Dominion Nuclear North Anna, LLC
5000 Dominion Boulevard, Glen Allen, VA 23060

DOMINION NUCLEAR NORTH ANNA, LLC
NORTH ANNA EARLY SITE PERMIT APPLICATION
RESPONSE TO NRC QUESTIONS AND REVISION 6 TO THE NORTH ANNA ESP APPLICATION

Enclosure 1
Dominion Response to March 2 and
March 13, 2006 NRC Questions

NORTH ANNA UNIT 3 CLOSED CYCLE CIRCULATING WATER SYSTEM DIAGRAM

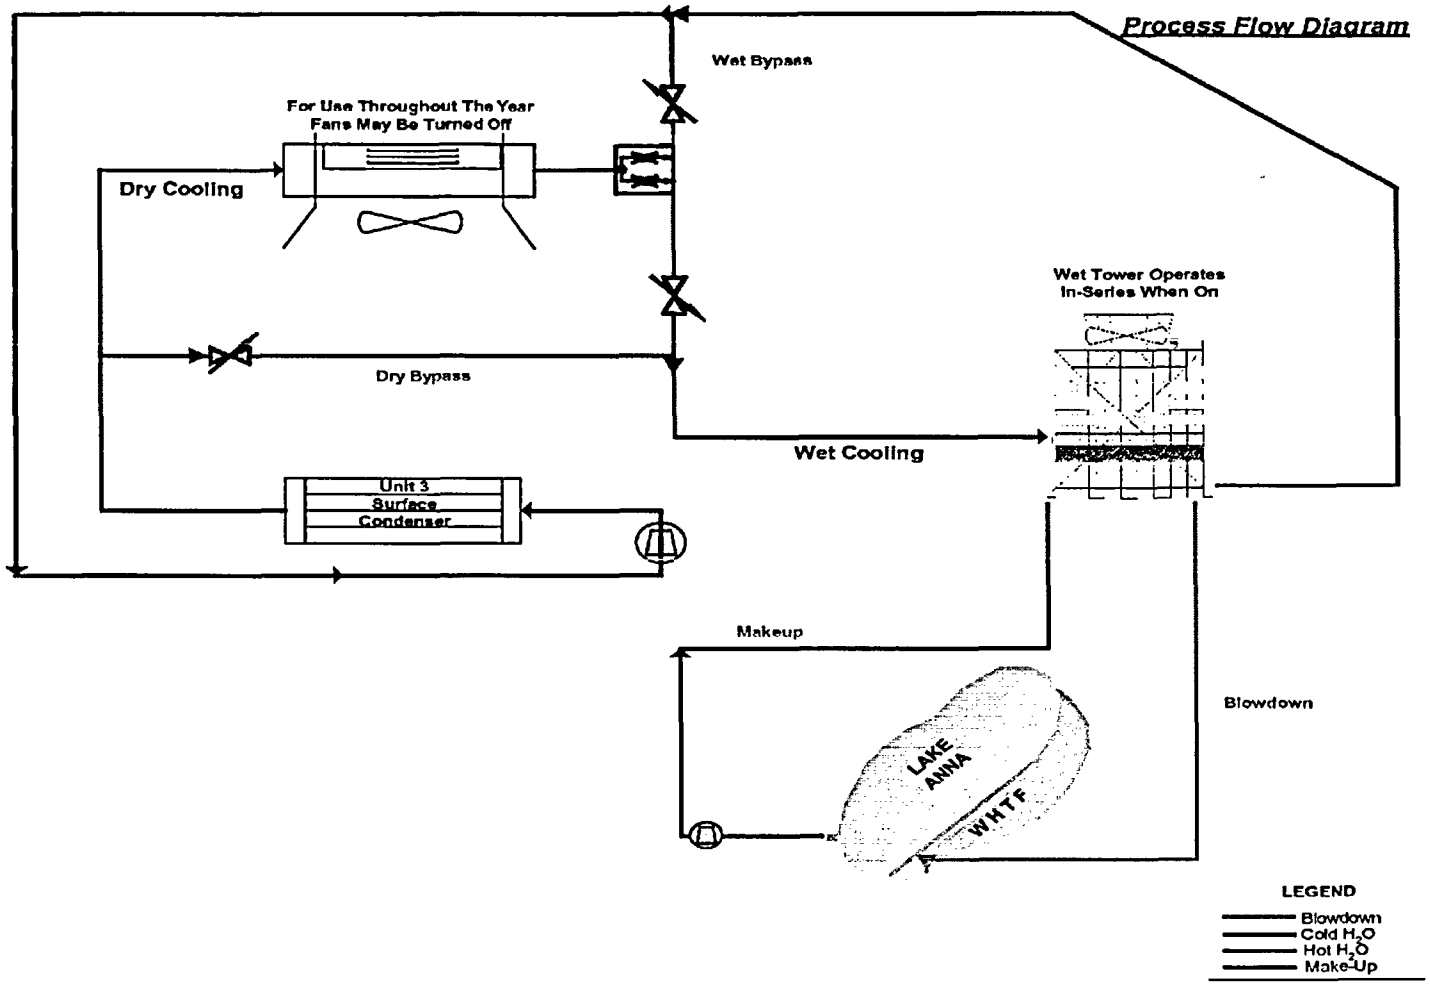
(1) Provide a conceptual description of the hybrid cooling tower system, its interaction with safety-related components, and an assessment of the reliability of this system.

(2) Describe how the hybrid cooling towers function for the normal cooling system (NCS) for the plant, and whether or not the NCS draws water from the ultimate heat sink (UHS) underground reservoir. If so, show how the remaining volume of water in the UHS reservoir will be adequate for a 30 day cooling water supply for safety system cooling.

The normal plant cooling system is a closed cycle system combining dry and wet cooling towers to provide the capability to reduce water consumption during drought conditions. The process flow diagram for the system is shown in the attached Figure. In the Maximum Water Conservation (MWC) mode of operation, heated cooling water leaving the plant main condenser would be cooled in a dry cooling tower section where a minimum of one-third of the heat would be rejected. The cooling water passes through the tubes of the dry cooler while fans move air across the outside of the tubes to transfer the heat to the air. After passing though the dry coolers, the water then passes through a wet cooling tower section, where the remaining heat is dissipated by spraying the water into an air stream, achieving the majority of the heat transfer by evaporation of a portion of the water. The cooled water then returns to the plant condenser to condense the steam leaving the turbines. When the system is in the Energy Conservation (EC) mode of operation, the dry tower fans are turned off with 100% of the cooling then provided using the wet tower section.

ER Section 3.4.1.1 is revised to include the diagram of the cooling system shown in the attached Figure and to describe examples of the water saving features that could be used in the wet towers. The figure in the ER Section also includes a plant service water system described in the section.

Figure 1: Flow Reduction ($\Delta Q = Q_2 - Q_3$) over Dam (from October 1978 to April 2003)

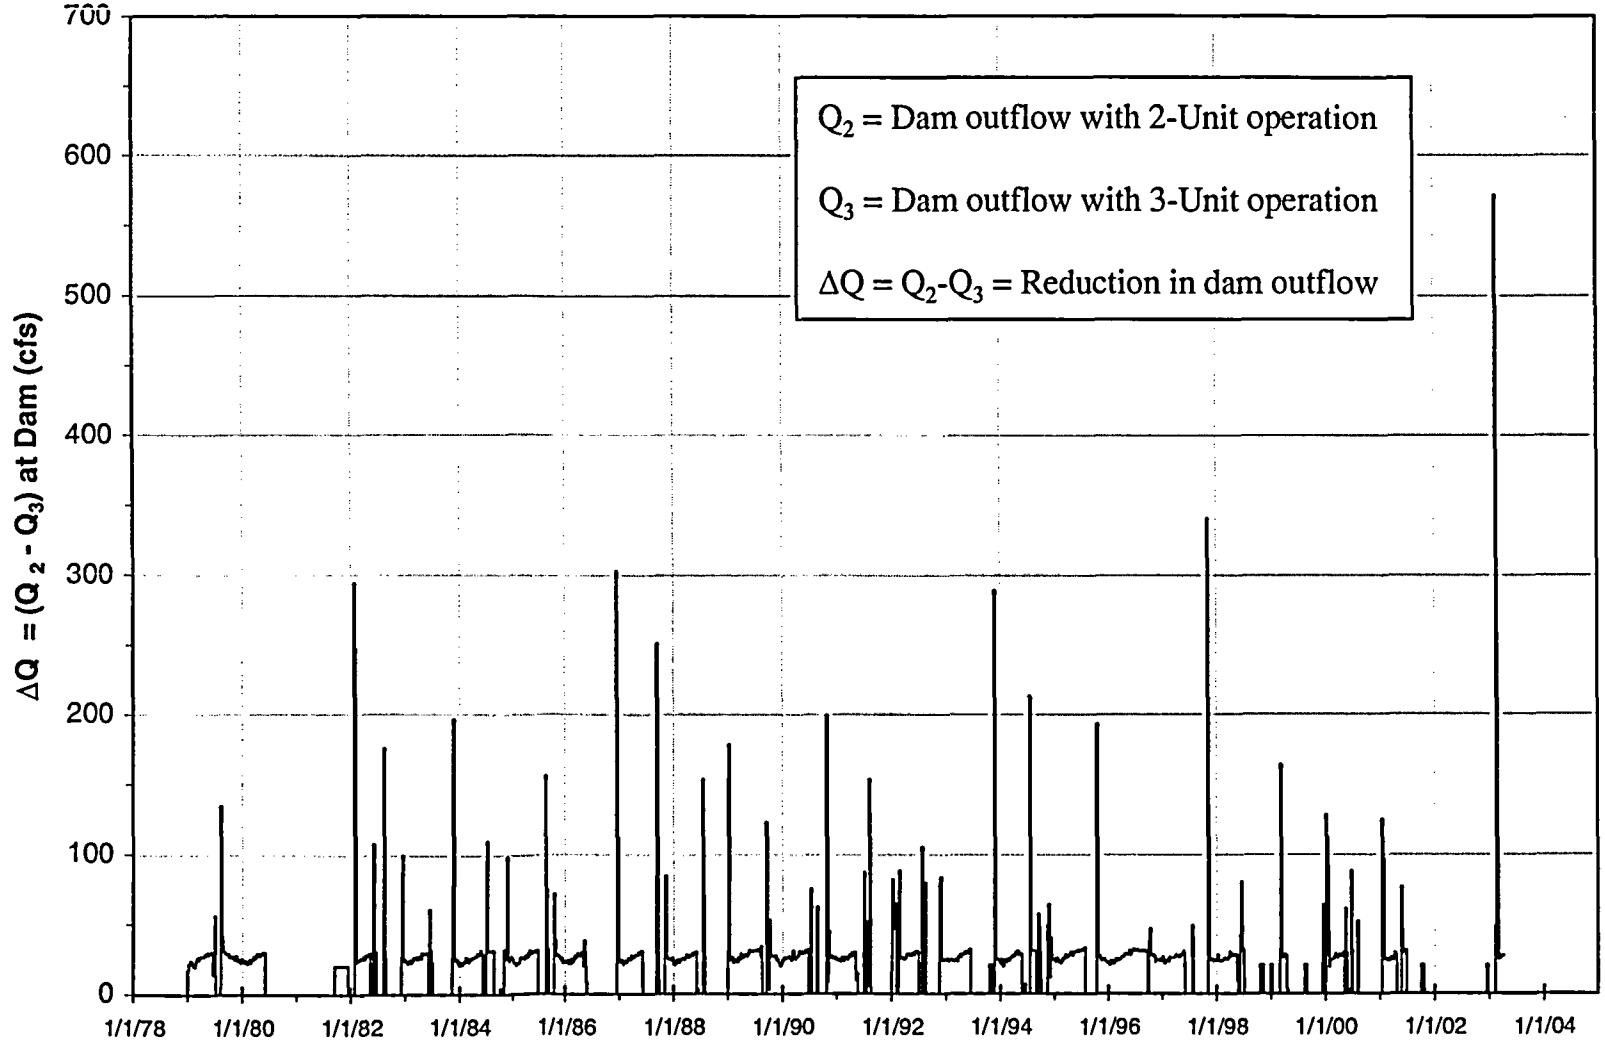
a. Section 5.2.2.2 states that the frequency of reduced flow from the dam would increase. Provide an analysis of the impact on fish and other aquatic communities in the North Anna River downstream of the dam. Specifically, address how the reduced water flow rates would affect environmental conditions at known striped bass spawning habitat areas during the striped bass spawning season.

The change in flow at the dam due to Unit 3 operation was calculated using the estimated weekly-average flows over the dam for two and three units for the period from October 1978 to April 2003. The period 1978-to-2003 was considered representative of flows expected in the future, including both wet and dry years. Flows in the Pamunkey River for the 3-unit operation were obtained by subtracting from the recorded flow at the Hanover gauge the estimated flow change at the dam between the existing condition and the expected future condition with Unit 3 operation. The flow values were calculated using a "running"

Certain characteristics of the changes in flow at the dam between 2-unit and 3-unit operation are apparent from these calculations as illustrated in Figure 1:

- There are short periods with a difference of 20 cfs, e.g., when 2-unit operation is releasing 40 cfs minimum flow, but 3-unit operation, with a lower lake level, would release 20 cfs, which would have occurred seven times in the 1978-to-2003 period, lasting one week to 3 months;

- There are periods when the 2-unit dam release is much larger (up to 550 cfs, but mostly 100 to 350 cfs) than the 3-unit release, due to the fact that runoff after a dry period fills the reservoir level to elevation 250 ft more rapidly for the 2-unit case and nearly all the river inflow is passed over the dam for a short period before the reservoir would have filled under the 3-unit scenario. Flow differences above 100 cfs would have occurred approximately 25 times in the 1978-to-2003 period, with each episode lasting a few days to two weeks.
